# Access Compliance Report

## Public Rights-of-Way

### (Curb Ramps)

Intersection ID: 2964	Main Street: COTTAGE_OAKS_DR	Cross Street: WAVERLY_LYNN_LN	Location: NE
ADA ID: A4F99B09A21A	Ramp Type: PerpDiag	Initial Pass/Fail: Fail	Overall Compliance: No
Severity Score: 8.75			
Codes/Mitigation Info/Possible Solution		Field Measurements/Component Compliance

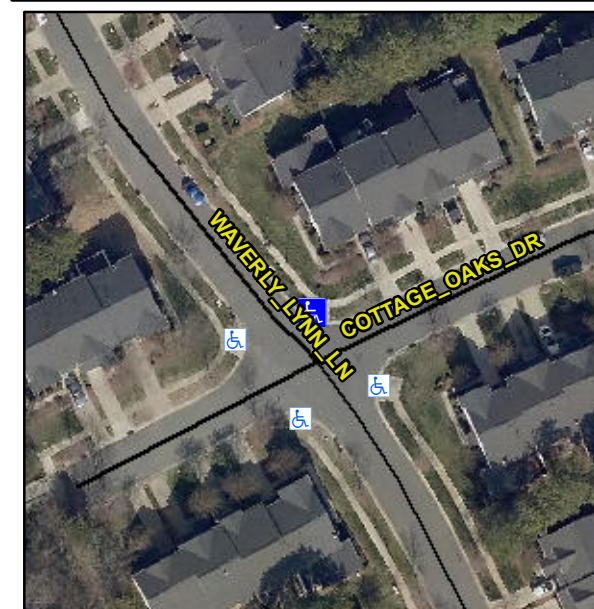
**Not Found, R304.5.1**

**Remove & Replace Curb Ramp With Two New Directional Ramps or Equivalent.**
